# UNITED STATES PATENT AND TRADEMARK OFFICE

APPLICATION NO.	FILING DATE	FIRST NAMED INVENTOR	ATTORNEY DOCKET NO.	CONFIRMATION NO.
10/764,121	01/26/2004	Joseph Larsen JR.		7872

<b>Office Action Summary</b>	<b>Application No.</b> 10/764,121	<b>Applicant(s)</b> LARSEN, JOSEPH	
	<b>Examiner</b> Timothy M. Ayres	<b>Art Unit</b> 3637

This is a first office action on the merits of application SN 10/764,121.

Dopp '678 Figures 11 and 12

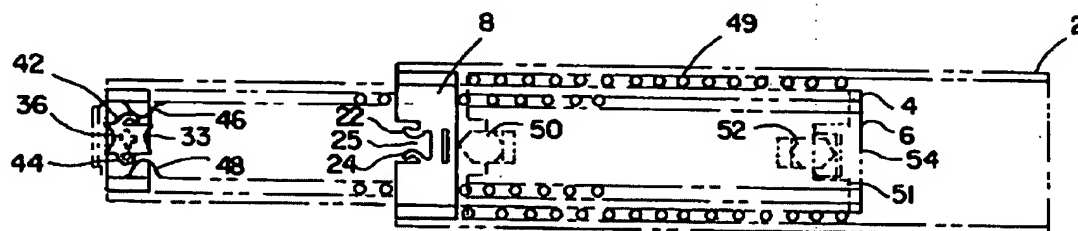
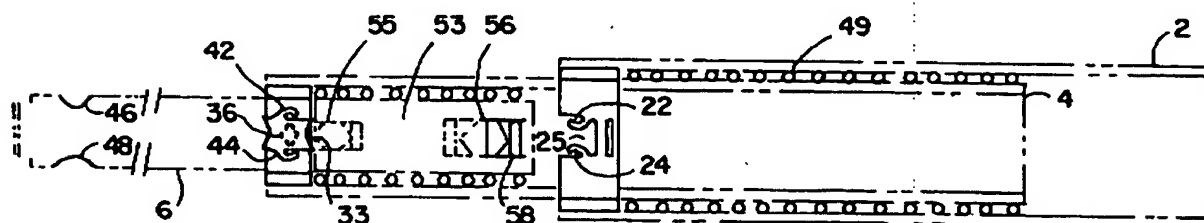
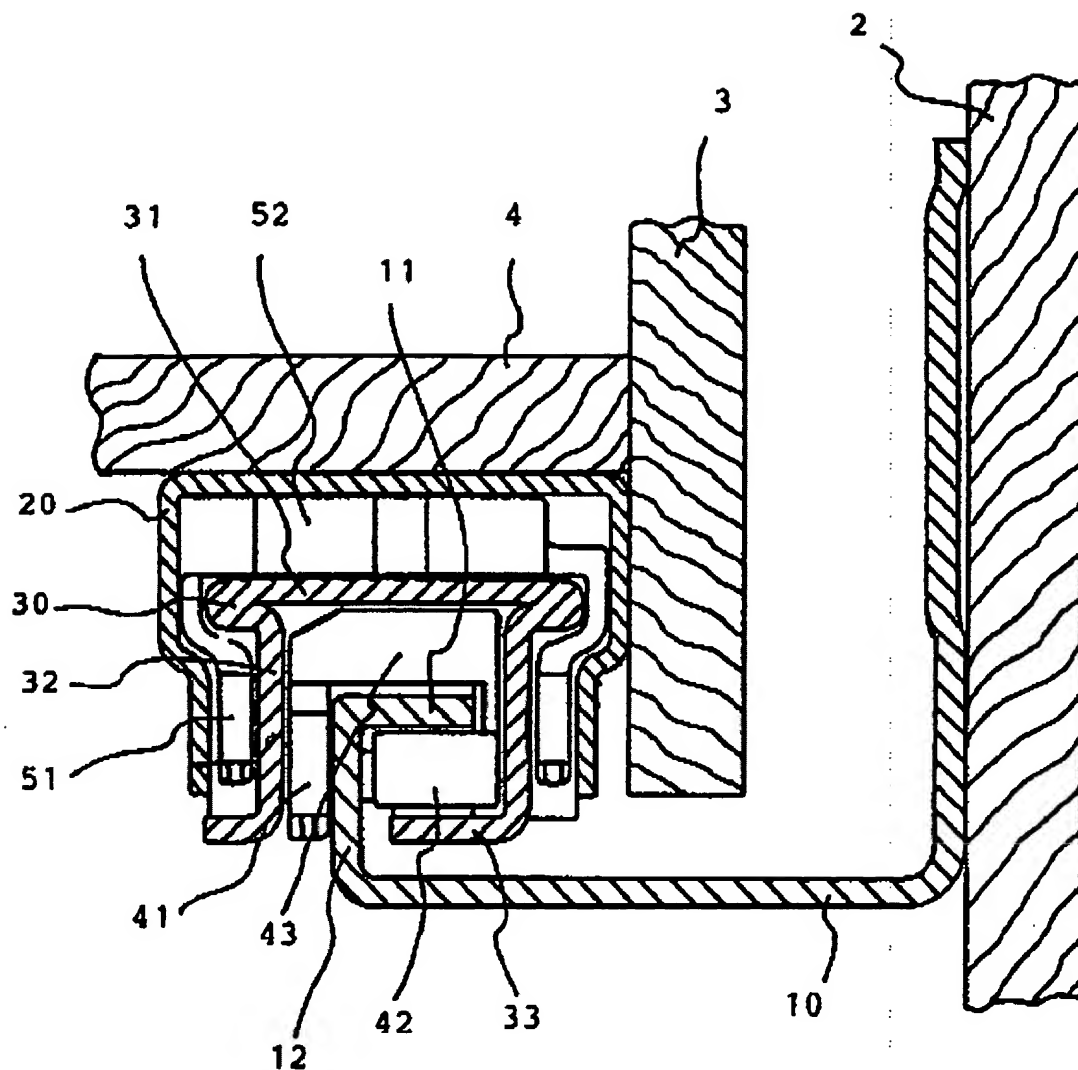
12. Claims 1-3, and 6 are rejected under 35 U.S.C. 103(a) as being unpatentable over US Patent 6,244,678 to Dopp in view of US Patent Publication 2003/0197452 to Kung. Dopp teaches a guide assembly comprising a supporting rail (2) mounted to a furniture sidewall and a pull out rail (6) secured to the drawer. An intermediate rail (4) is mounted between the supporting rail (2) and the pull out rail (6). A first carriage (51)

positioned between the supporting rail (2) and the intermediate rail (4). A second carriage (53) provided between the intermediate rail (4) and the pull out rail (6). The supporting rail (2) and the intermediate rail (4) having at least one stop (33,40,8,12) for limiting the movement of the pull out rail (6), the intermediate rail (4), and the first carriage (51) with respect to the supporting rail (6). The first and second carriages (51,53) have three walls and form a U-shaped member as best understood by the figures. Two of the walls have roller cages located on them with rollers in the cages as best seen in figures 11 and 12. One of the walls has a bumper (50, 52) at the forward edge that project forward and has a bumper (55,56) at the rearward edge that project rearward.

13. Dopp does not expressly disclose that all three of the walls have roller cages and a third carriage is held between the stop of the intermediate rail and the stop of the pull out rail in the forward position. Kung teaches a guide assembly with a pull out rail (20), a supporting rail (10), and an intermediate rail (30). A first carriage (40) is located between the intermediate rail and the supporting rail. A second carriage (50) is located between the intermediate rail and the pull out rail. The carriages are U-shaped with three walls each having at least one roller cage and roller (41,42,43, 51, 52). At the time of the invention it would have been obvious for a person of ordinary skill in the art to modify Dopp by having roller cages with rollers located on the third wall as taught by Kung so that the slide is more durable and quiet (Kung '452, paragraph 3).
